**Economic and Social Council**Distr.: General  
10 February 2016

**Economic Commission for Europe****Inland Transport Committee****World Forum for Harmonization of Vehicle Regulations****Working Party on General Safety Provisions****110<sup>th</sup> session**

**Regulation No. 110 (CNG and LNG vehicles)****Proposal for amendments to Regulation No. 110  
(CNG and LNG vehicles)****Submitted by the expert from the International Organization for  
Standardization\***

Figure H.1

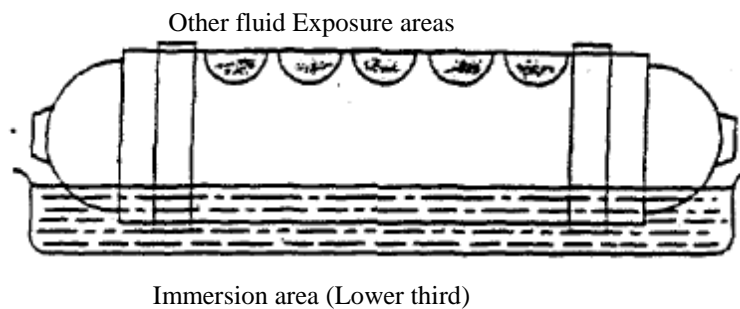
~~Cylinders will be tested horizontally and nominally divided along their horizontal centreline into "upper" and "lower" sections. The lower section of the cylinder will be alternatively immersed in road salt/acid rain environment and in heated or cooled air.~~

The upper section will be divided into 5 distinct areas and marked for preconditioning and fluid exposure. The areas will be nominally 100 mm in diameter. The areas shall not overlap on the cylinder surface. While convenient for testing, the areas need not be oriented along a single line, but shall not overlap the immersed section of the cylinder.

Figure H.2  
Gravel impact test

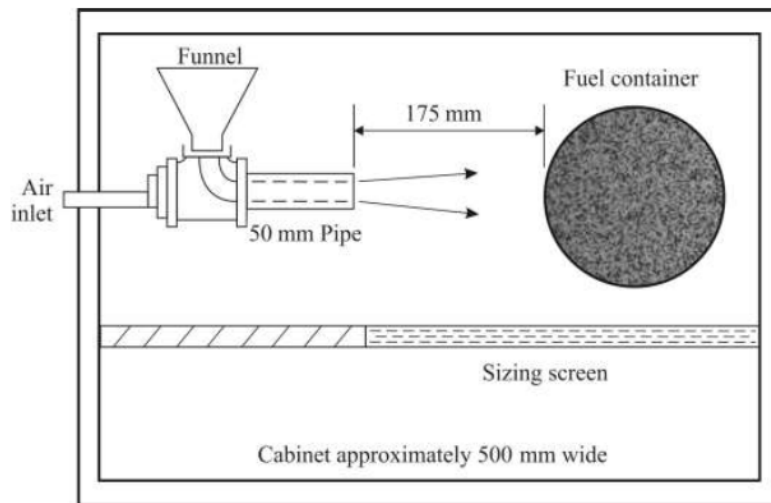
~~Machine constructed according to the design specifications shown in Figure H.2. This procedure for operation of the equipment shall follow that described in ASTM D3170, Standard Test Method for Chip Resistance of Coatings with the exception that the cylinder may be at ambient temperature during gravel impact;~~

~~Alluvial road gravel passing through a 16 mm space screen but retained on a 9.5 mm space screen. Each application is to consist of 550 ml of graded gravel (approximately 250 to 300 stones).~~
